ADMINISTRATIVE REPORT

Title: DAV 25-117254\C – 436 Balmoral Street

Issue: For a Variance associated with an 18-storey 150-unit multi-family dwelling.

FLOOR 3 - PLAN

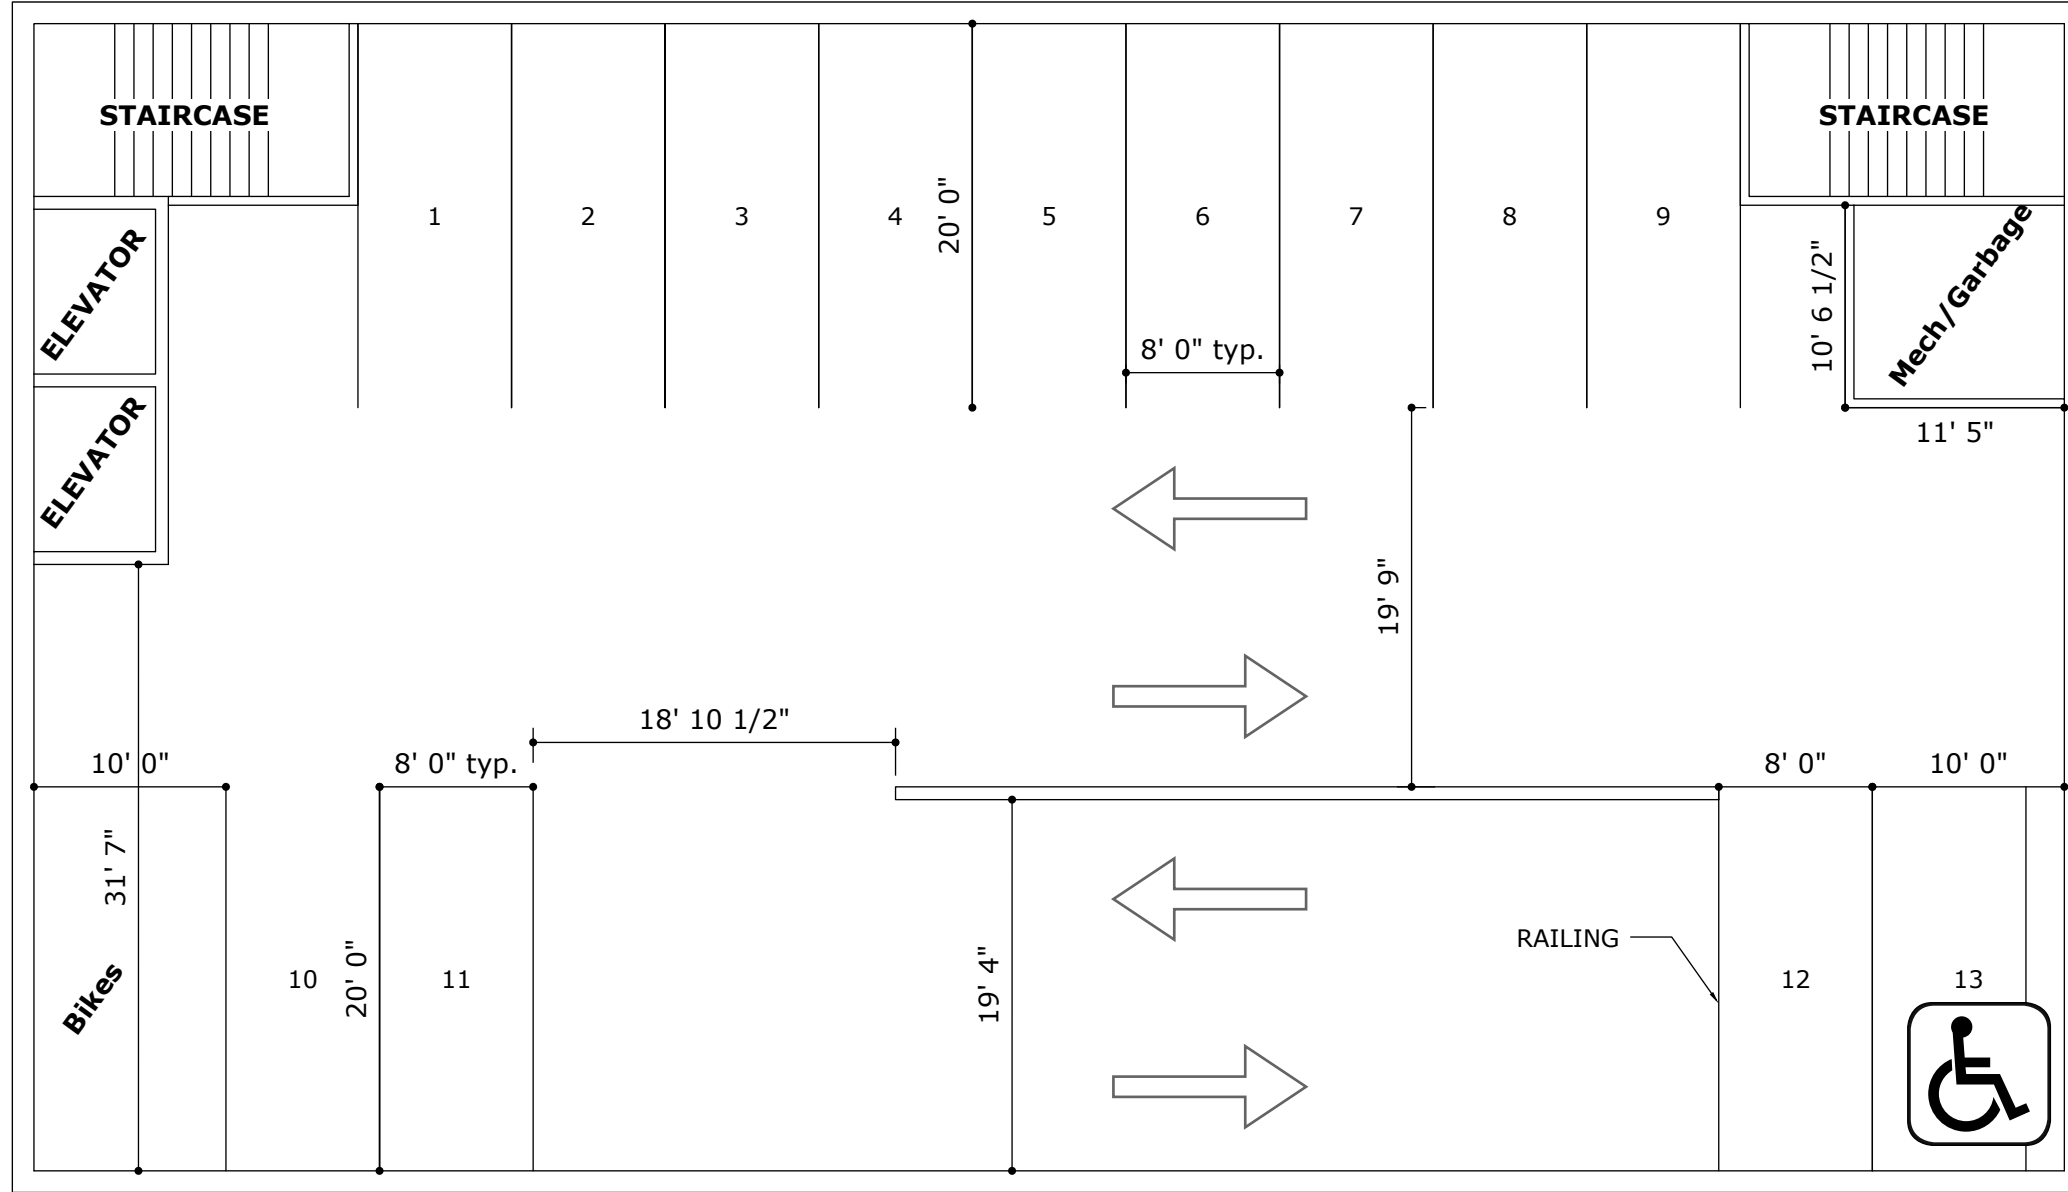
Reduced Parking:

- With the rationale that this area of the city is pedestrian, bike, and transit friendly, a parking reduction is not uncommon, however, a parking reduction of this magnitude (58 spaces instead of required 186 (36 for proposed Lot 1 and 150 for proposed Lot 2) would typically only be supported with the provision of affordable housing and car share vehicle(s) in addition to indoor bike parking.
 - The proposal does not provide parking offsets, such as affordable housing and car share vehicle(s) and thus the Division does not support this Variance.

Substandard Drive Aisles:

- The minimum 20-foot parking aisle aides in the safe and efficient maneuvering and movement of vehicles when there is two-way traffic.
- The substandard drive aisle widths potentially pose adverse effects for drivers moving in/out of the proposed development for Lot 2 as well as potentially impacting the safety of residents, guests, and others who will move in/around the parking areas and for those who will use the off-street parking spaces. Although 18 feet is a minor Variance it must be viewed together with the other requested Variances for this application.
